**RE: ADMINISTRATIVE DESIGN REVIEW CASE NO. PDR 1912804
1339 CAPISTRANO AVENUE**

**CITY OF GLENDALE, CA
DESIGN REVIEW STAFF REPORT – HILLSIDE SINGLE FAMILY**

Thrall Residence Addition

Percentage of Remodel Calc

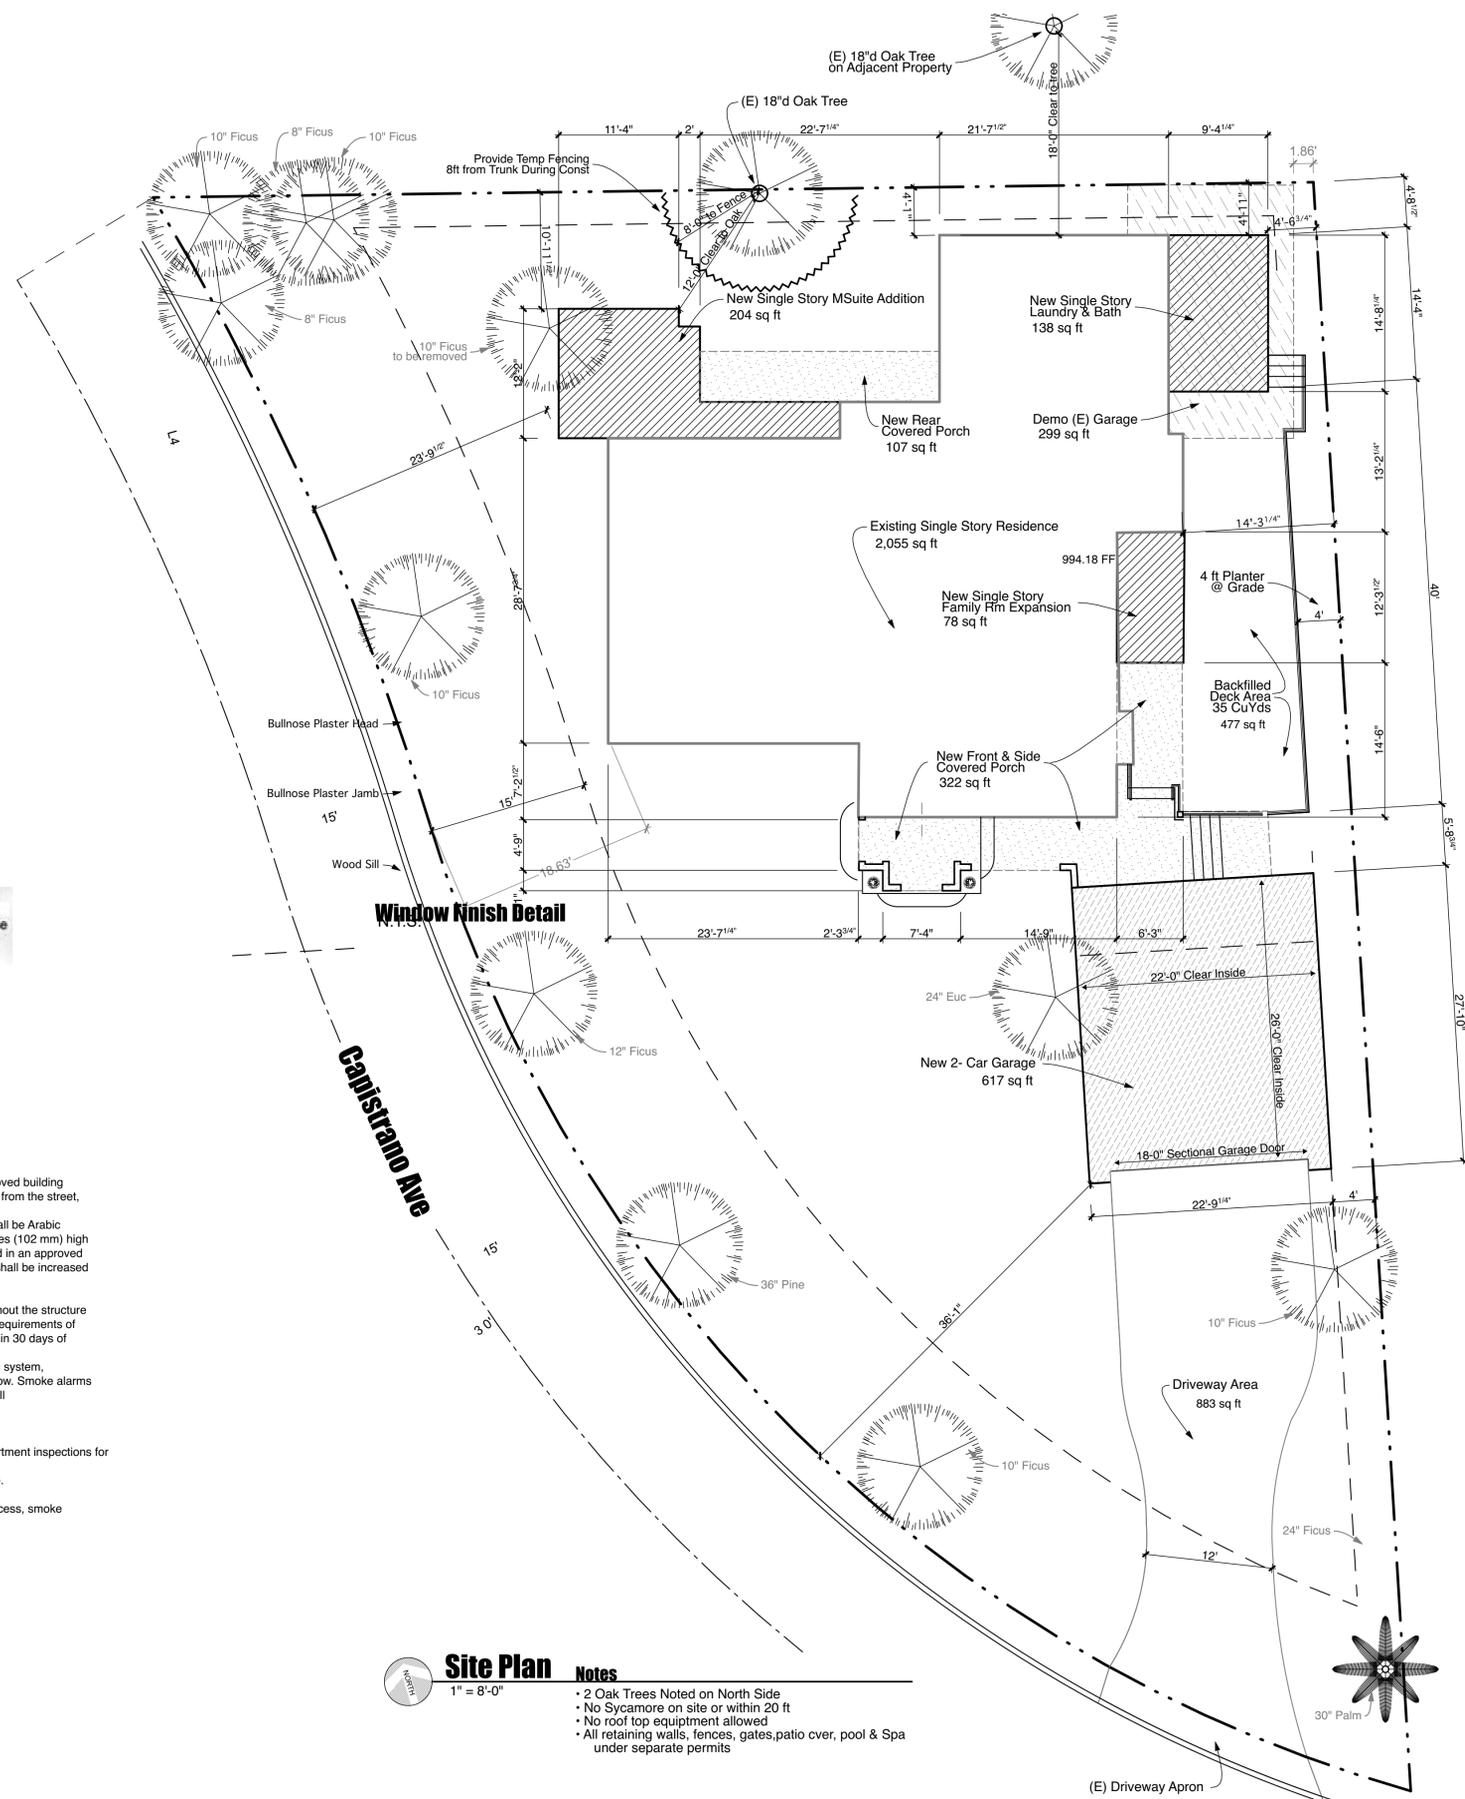
The plans indicate that the total demolition of outside wall and roof area combined is 33.4%. Should demolition exceed 50% of the total outside wall and roof area during construction, per GMC 30.60.040.B.2, the building loses its nonconforming status and must be brought into compliance with the current Zoning Code. This will include, but is not limited to, required setbacks, parking, and Design Review Board approval for new single-family construction.
